**801i / 902i Sensor Block Resistor Locations**

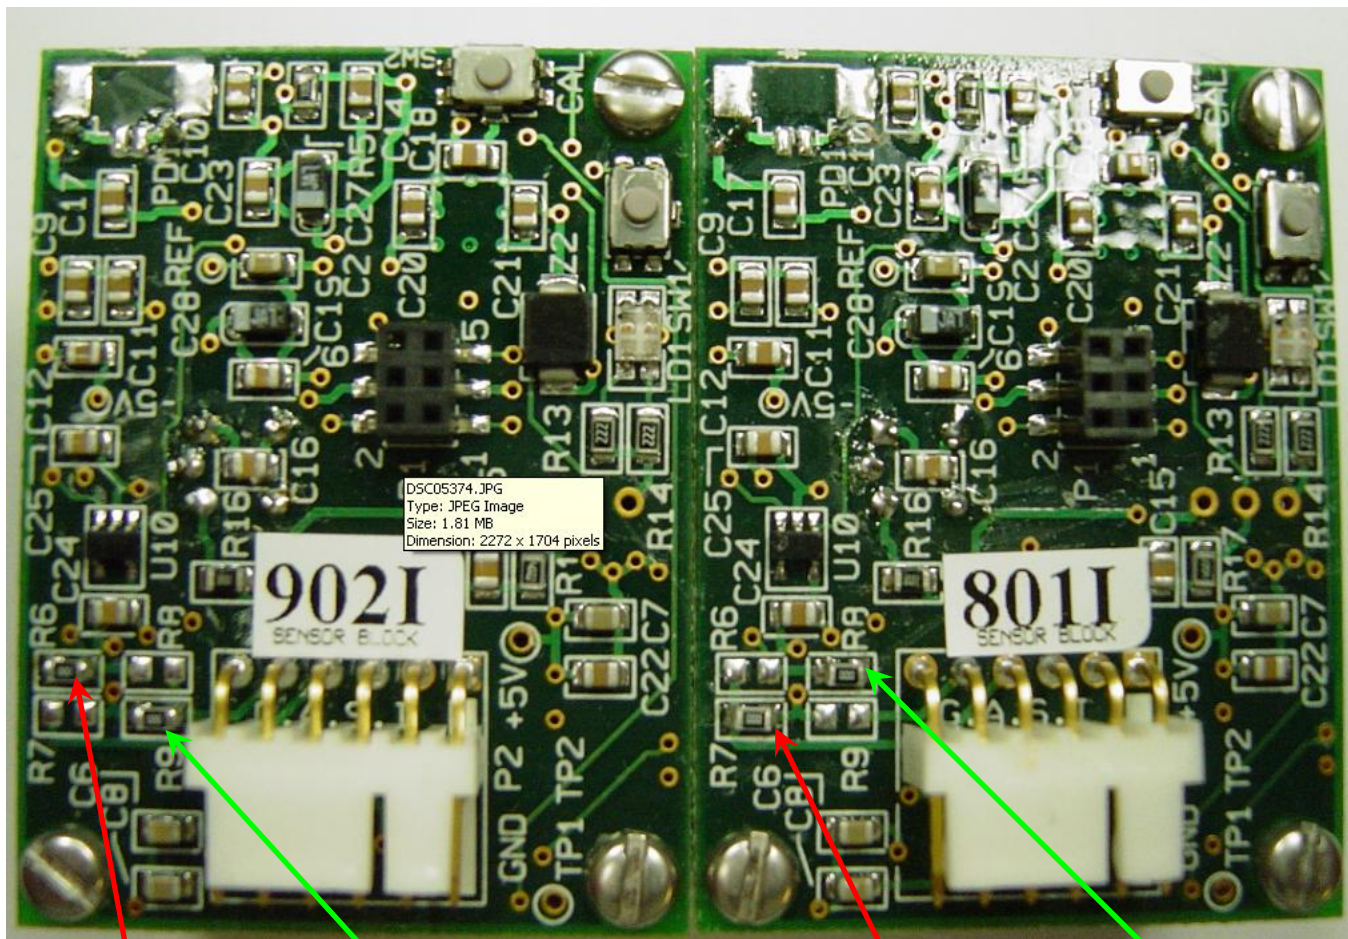
This service bulletin is to inform Galvanic's customers and service department of an issue where a small number of sensor assemblies had been produced with an incorrect resistor configuration. Although the incorrect sensor assemblies had been tracked down and reconfigured, this service bulletin has been released in order to help easily identify the correct configuration of resistors.

**R6**  
Resistor  
location for  
sensor block  
902I

**R9**  
Resistor  
location for  
sensor block  
902I

**R7**  
Resistor  
location for  
sensor block  
801I

**R8**  
Resistor  
location for  
sensor block  
801I
